Contract HK 12/02
Central Reclamation Phase III – Engineering Works
Environmental Permit No.: FEP- 01/122/2003

**Certification and Verification for Change of FEP Condition 3.2 –
Concurrent Dredging/ Filing at FRAW & FRAE**

ET Leader's Certification

...MarineArea layout_plan_rev2.dwg 2007/5/2 下午 04:17:52

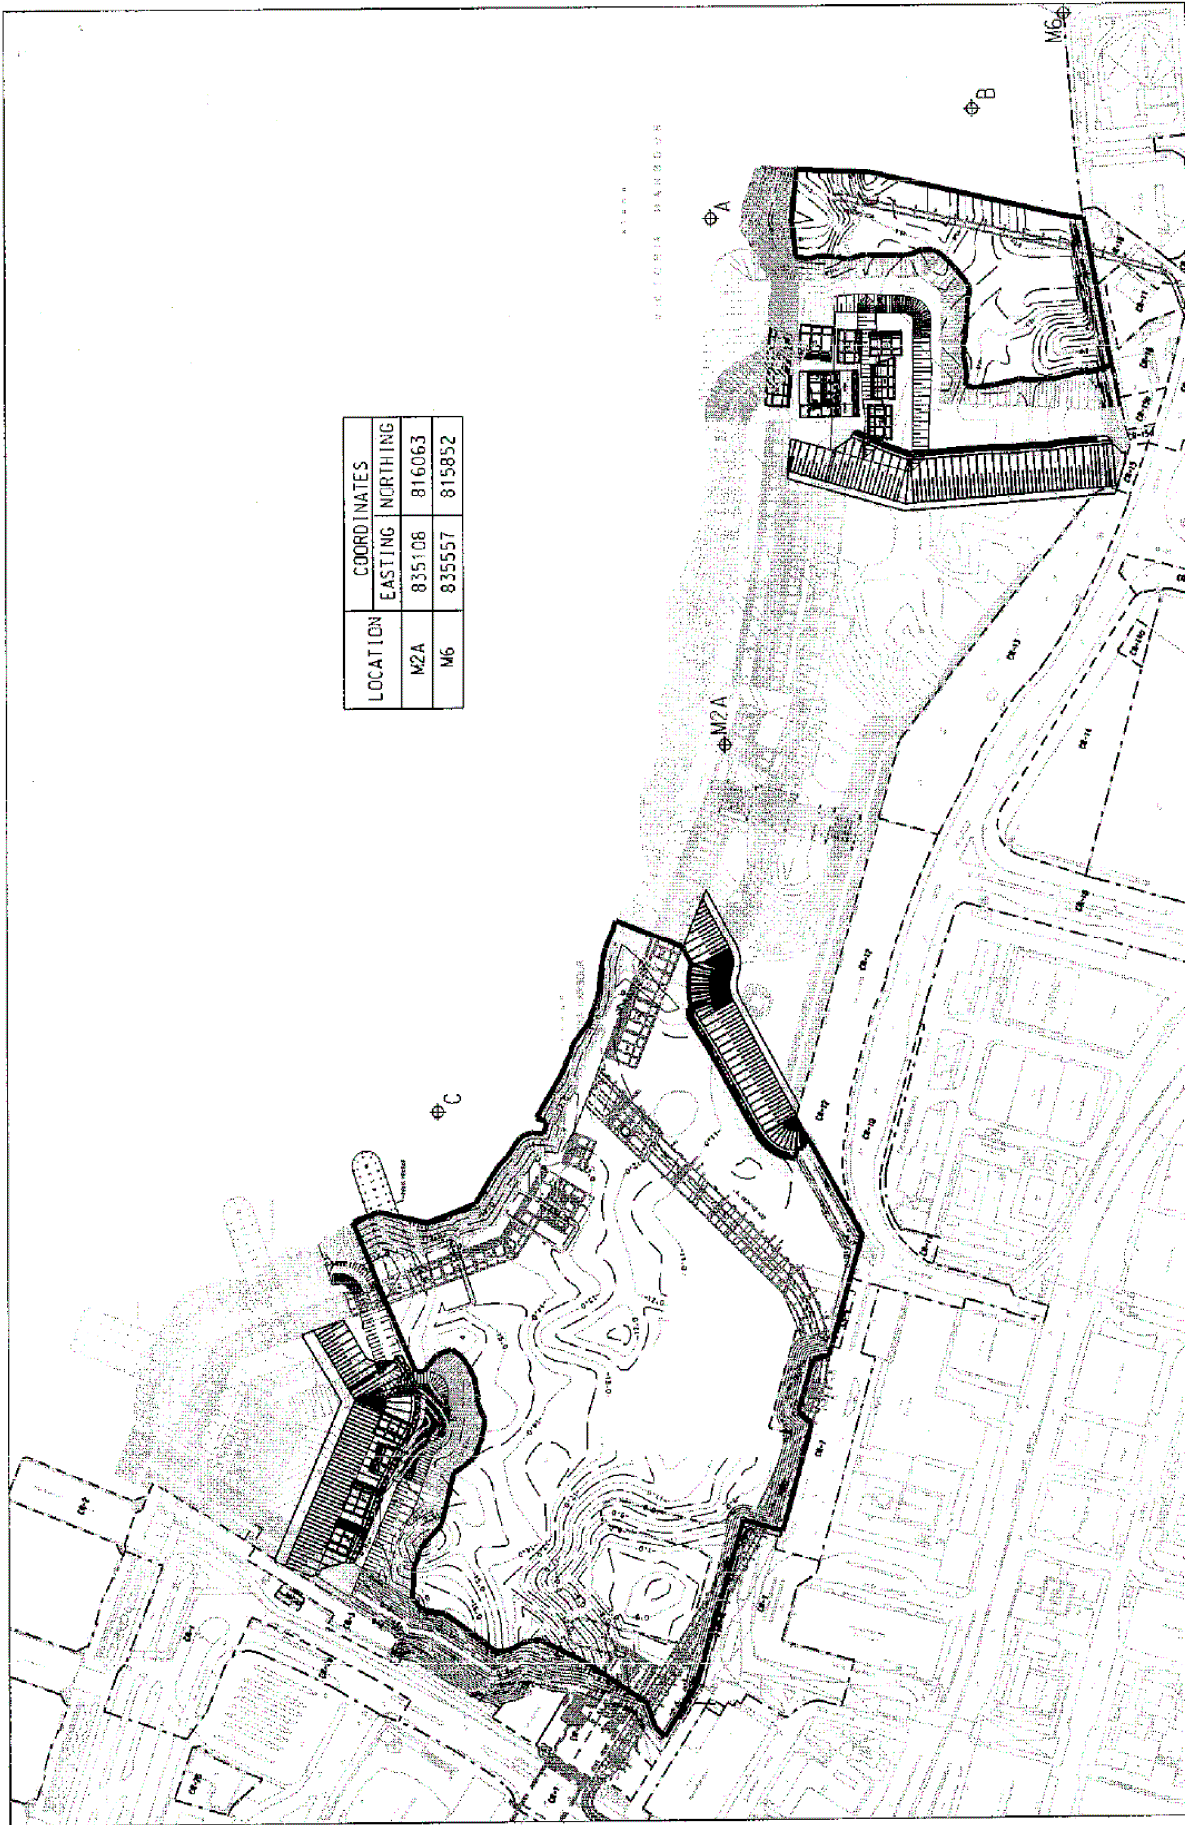
(2) The JV shall undertake additional water quality monitoring at stations M2A & M6 during mid-flood and mid-ebb tide on the days that monitoring is not undertaken by the ET as part of the routine water quality monitoring for a trial period of 10 days (First 5-days for dredging at 220m³/h at FRAW and next 5-days for dredging at 260m³/h)

Further sampling at 3 additional (mobile) monitoring stations (i.e. A, B & C) within 50m of the immediate area of the dredging works (A and C being to the North of the dredger at FRAE and FRAW respectively, while B being in between the dredger operating at FRAE and M6) shall be undertaken immediately after completion of dredging works each day during the 10-day trial period.
